**Include General Definition Section**

Amend **Rule 8 – Bonus Density** as follows:

**Amendment to Rule 10(3)(a) – Setback Areas**

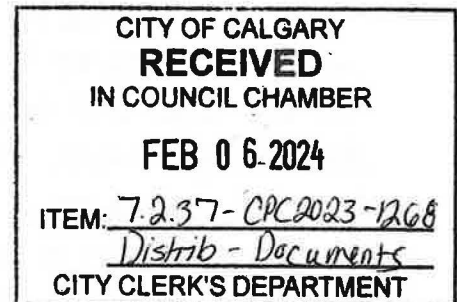
“In this Direct Control District “***corner cut setback area***” means an area at the intersection of Kensington Road and 10 Street NW defined by a straight-line intersecting with two ***property lines*** at a minimum distance of 4.5 metres along each of the ***property lines*** from the former where they meet, as shown in Illustration 1. (An illustration will need to be included).”

The intent of this request is it ensures the minimum distance of 4.5m from the corner is achieved, as this would allow for a pedestrian refuge to evolve.
